| STONE & WEBSTER ENGINEERING CORPORATION NINE MILE POINT NUCLEAR STATION - UNIT 2 NIAGARA MOHAWK POWER CORPORATION J. O. 12177 | | MANUFACTURER'S DRAWING DATA FORM | | | | | | | | | | | | | | | | | | | | | | | | | | | | | | | |
| MFR'S DWG. NO. (LIMIT TO 24 CHARACTERS & BLANKS) (E1) (E2) 110 714 010 REV C | | MACHINE DESIGN/VESSEL NOTED NOV 13 1980 B. Russell | | | | | | | | | | | | | | | | | | | | | | | | | | | | | | | |
| PROJECT TITLE (LIMIT TO 100 CHARACTERS & BLANKS) (E1) (E2) OUTLINE DWG-76 KVA-REVERSE TRANSFER UPS SYSTEM | | PROJECT CLERK (E1) DESIGN ENGINEER (E1) RESP. ENGINEER-ON-DWG RECEIPT (E1) RESP. ENGINEER-AFTER-DWG REVIEW (E1) MICROFILM APERTURE CARD (E1) REV. ENGINEER INITIALS | | | | | | | | | | | | | | | | | | | | | | | | | | | | | | | |

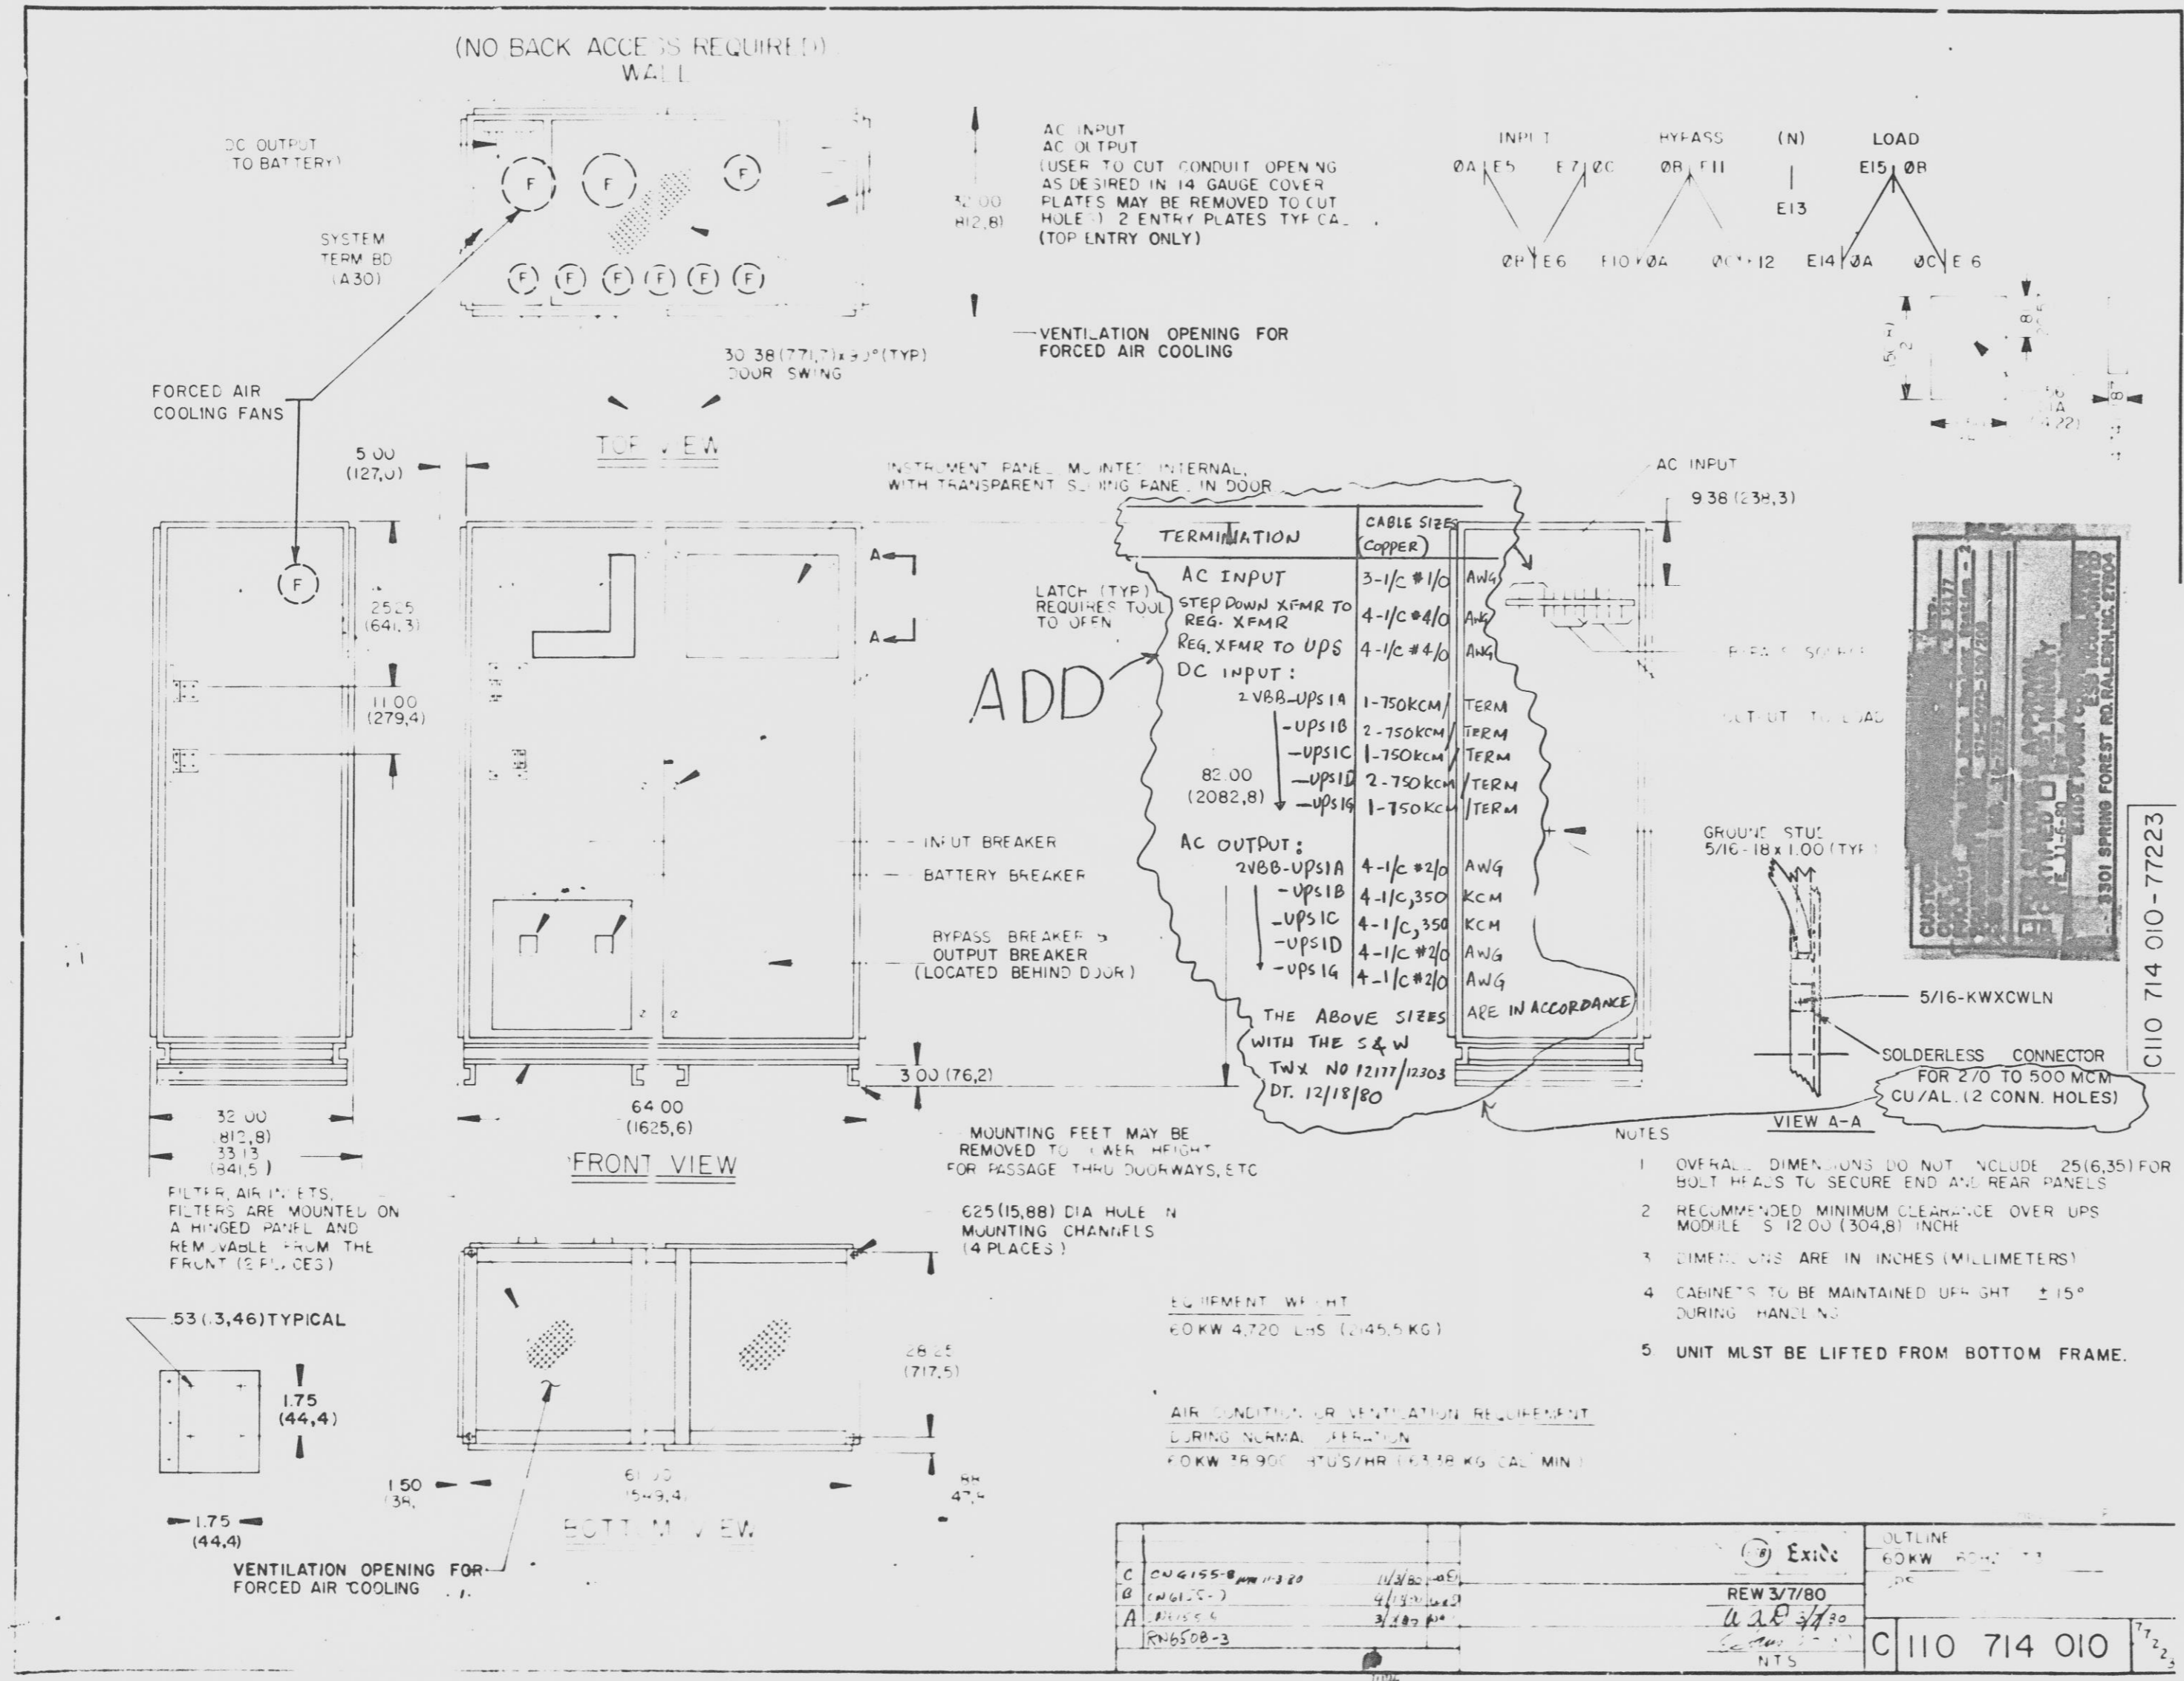
| <input checked="" type="checkbox"/> INSTRUCTIONS TO SUPPLIER (E2) <input checked="" type="checkbox"/> APPROVED AS REVISED (AS DEFINED IN SPECIFICATION) <input checked="" type="checkbox"/> RELEASED FOR FABRICATION <input checked="" type="checkbox"/> RELEASED FOR MATERIAL PURCHASE | | RESP. ENG. R. V. RAO (E1) RESP. DES. ENG. B. RUSSELL (E1) | | | | | | | | | | | | | | | | | | | | | | | | | | | | | | | |
